Product Change Notification

Date Issued :	June 14, 2023	PCN Number :	513807
Reason for Change :	Equipment Transfer, Production Transfer or Rearrangement		
Description of Change :	This notification is to inform you about an additional equipment transfer that has been issued to manufacture impacted part(s). No changes will be made to product as part of this change. These PN's are from the same series as the PCN 513522 & 513522 previously communicated.		
Reason for Short Notice :	Update Previously Issued Change Notice		
Assessment of Change :	No change to parts - Form/Fit/Function Reliability Test Report/s		
Planned Implementation Date :	September 29, 2023		
Sample Availability Date:	July 10, 2023		
Internal Molex Qualification Date :	July 10, 2023		
Last date to request Samples by Customer :	September 15, 2023		
Traceability Code Markings / Date :	Date code

Guadalajara 2

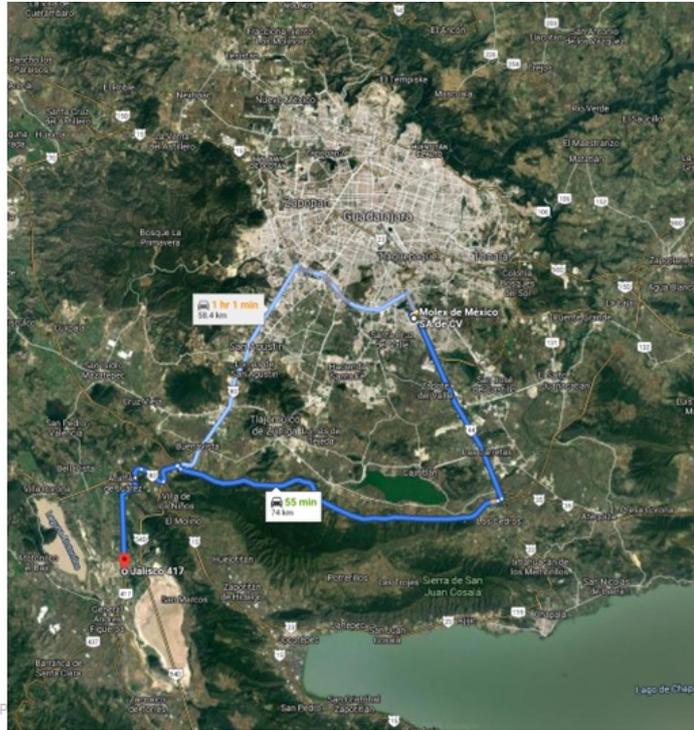
- Located in Centro Logistico Jalisco Industrial Park
- 1 hour from existing Guad1
- Initial build will contain Molding, Assembly, and Reliability Testing capabilities
- A new Distribution Center services Guad2
